[Docket No. FAA-2012-0415; Directorate Identifier 2008-SW-065-AD]

Airworthiness Directives; Bell Helicopter Textron, Incorporated Helicopters

ACTION: Notice of proposed rulemaking (NPRM).

Figure 1. Inspection of Main Rotor Hub Grip Tangs

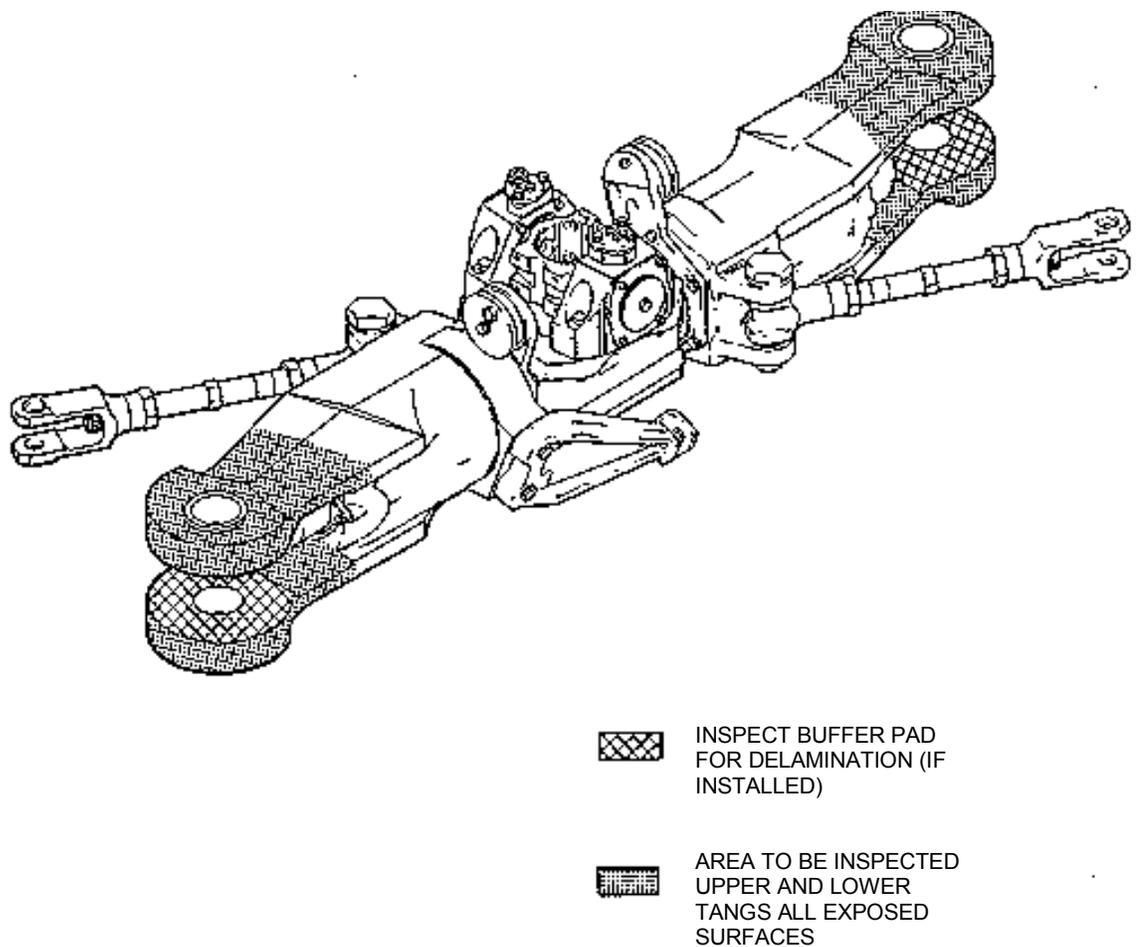
(ii) Using a 10-power or higher magnifying glass, visually inspect the exposed surfaces of the upper and lower tangs of each grip for a crack. Pay particular attention to the lower surface of each lower grip tang from the main rotor blade bolt-bushing flange to the leading and trailing edge of each grip tang. See Figure 1 of this AD.

- (i) Remove each main rotor blade, and
- (ii) Inspect each grip buffer pad on the inner surfaces of each grip tang for delamination (see Figure 1 of this AD). If there is any delamination, remove the buffer pad and inspect the grip surface for corrosion or other damage.
